ORDINANCE NUMBER 2016-09

**AN ORDINANCE OF THE TOWN OF PARADISE VALLEY,
ARIZONA AMENDING THE PARADISE VALLEY ZONING
ORDINANCE, Article XXII, HILLSIDE DEVELOPMENT
REGULATIONS**

November 21, 2017 Draft

FIGURE 3 PRIMARY RIDGE LINE DESIGNATION

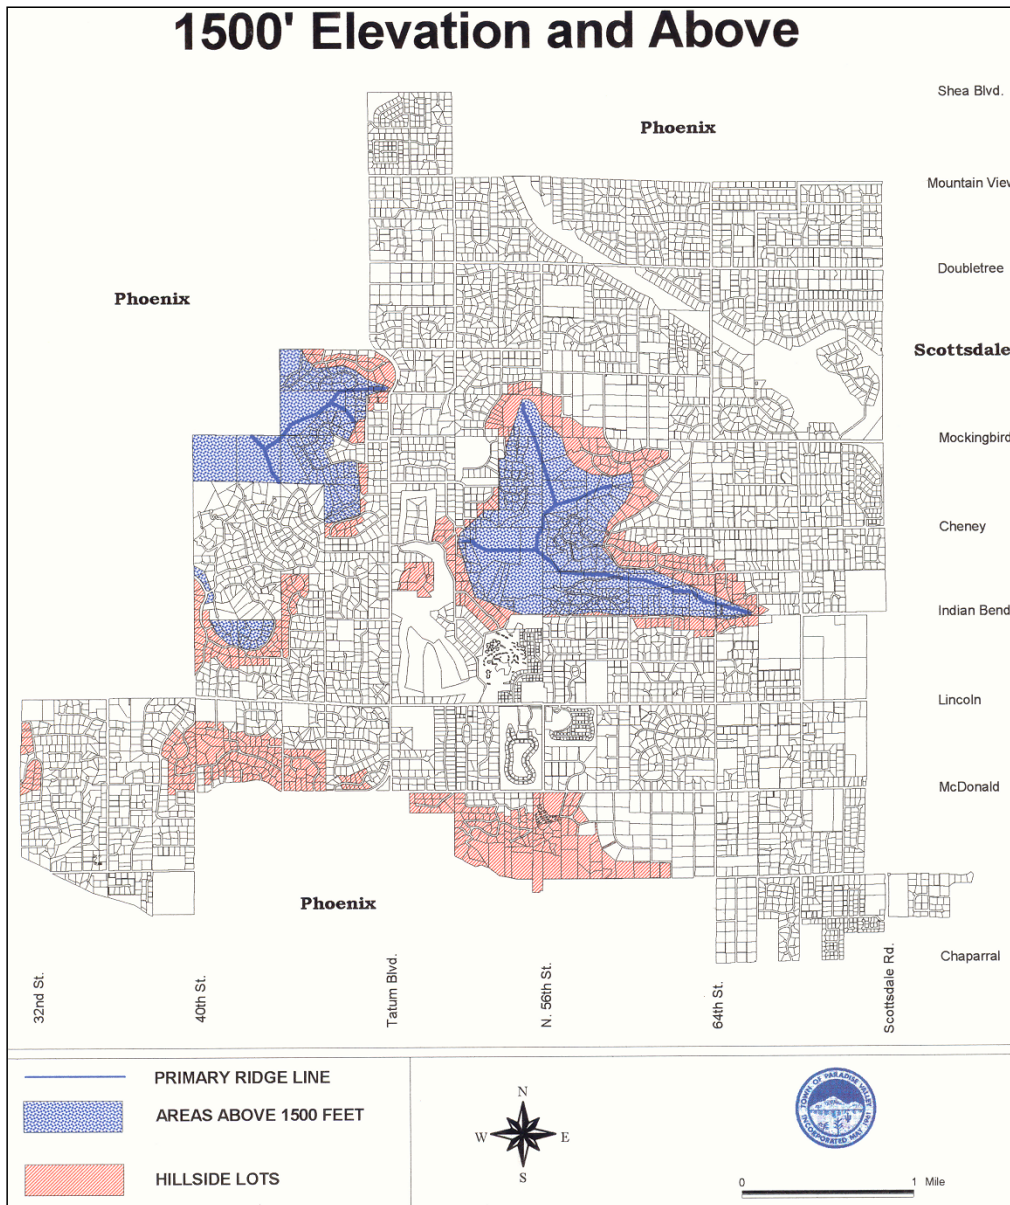
Commented [GB1]: Figure 3 Moved after Definition Section on Page 9

ADD FIGURE ILLUSTRATING 16' HEIGHT LIMIT.FIGURE 5a

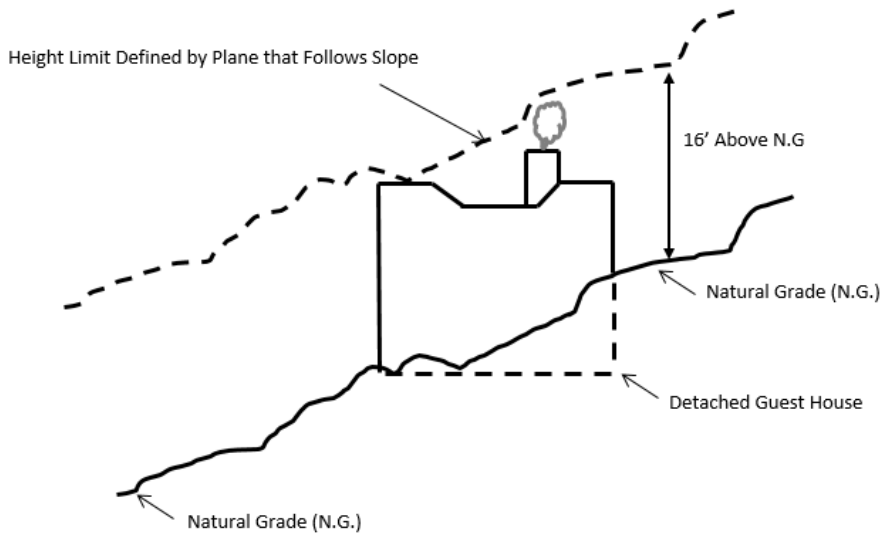
- i. The height of an accessory building or accessory structure is limited to a sixteen foot (16') imaginary plane that parallels the existing pre-development Natural Grade, as measured vertically from any point under the building. (see FIGURE 5a)

FIGURE 5 – BUILDING HEIGHT IN HILLSIDE

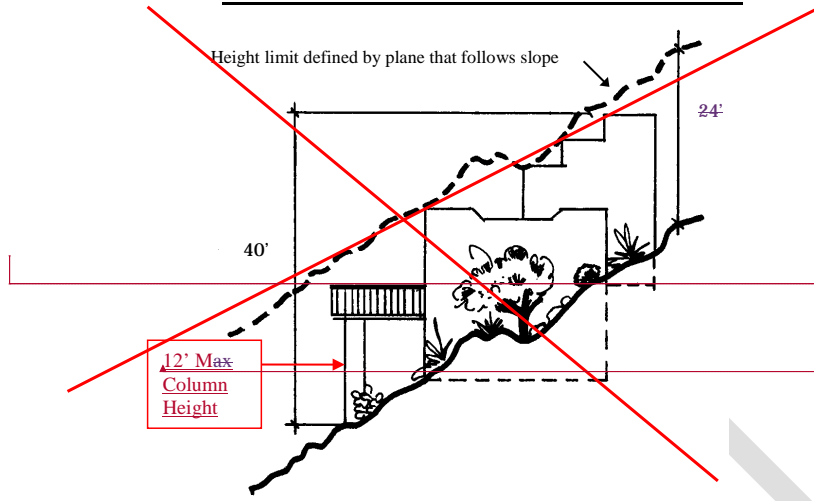
- iii.3. The maximum overall height of the building or structure, including chimneys and accessory buildings, shall not exceed forty (40) feet from the highest point of the building to natural grade at the lowest point adjacent to the building structure or column of a building or structure to the lowest point of Natural Grade at the lowest building or structure (excluding driveway retaining wallsRetaining Walls) (see FIGURE 5).

Commented [GB4]: Figure 5 to be updated to reflect these edits.

Commented [GB5]: Update Figure 5 to clarify measurement of 40' maximum height limit.

FIGURE 7 - HEIGHT FOR A CANTILEVERED ELEMENT

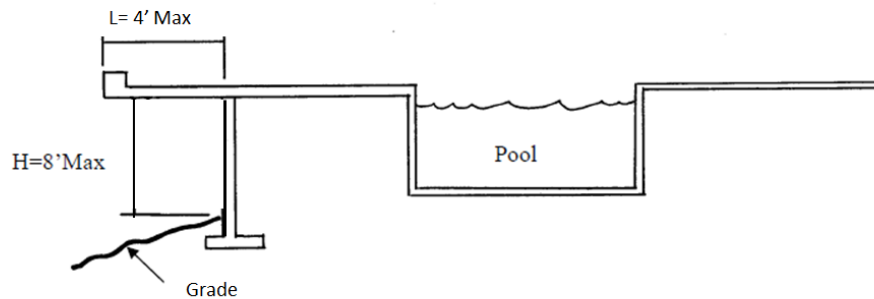
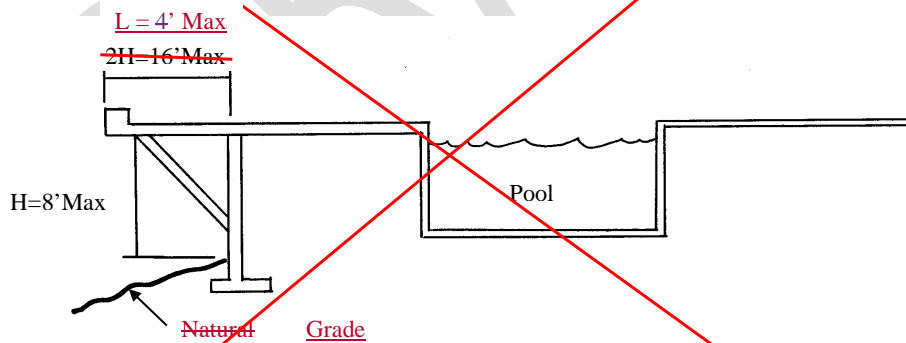
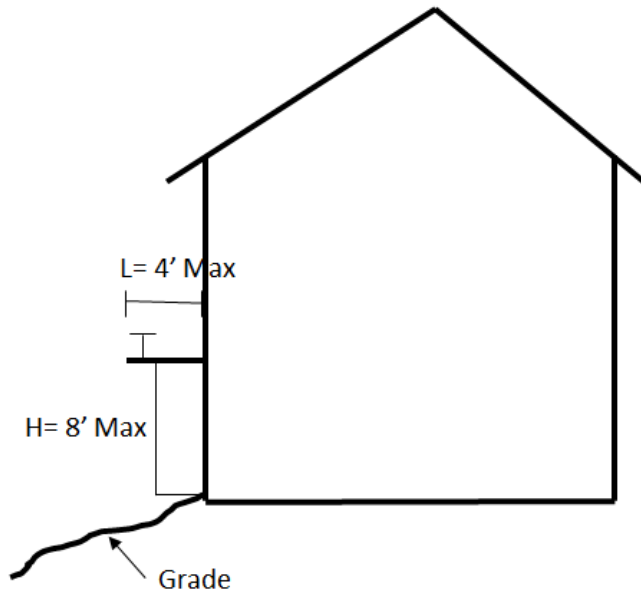
2. All other structures (such as pool decks). Cantilevered elements of the structure must comply with the applicable setbacks and heights of the structure. Structures employing the use of a cantilever Cantilever may extend the cantilever Cantilever a maximum horizontal length of 4 feet and a maximum vertical height of 8 feet from adjoining grade. All of the area underneath the cantilever Cantilevered element shall be calculated as disturbed area Disturbed Area and shall be included in the disturbed area Disturbed Area calculation. (See FIGURE 7).

Commented [GB6]: New figures to be added to the code to illustrate these scenarios.

Commented [GB7]: Remove support from illustration and change horizontal to 4' max on Figure 7.

FIGURE 8 TERRACED VERTICAL RETAINING WALLS

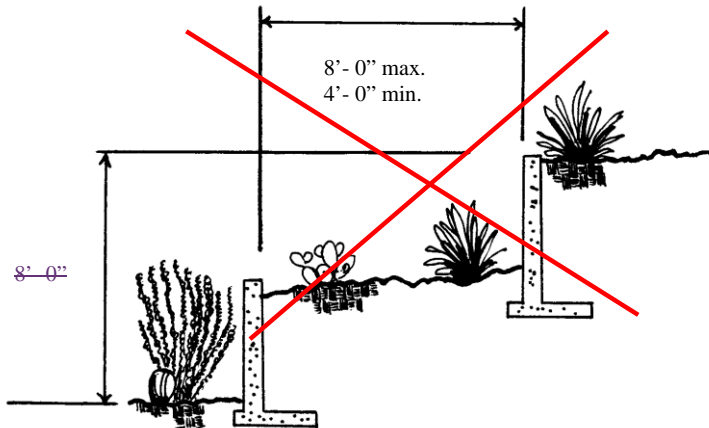
Commented [GB10]: Relocate Figure 8 below the text of 2207.VI.1.e.
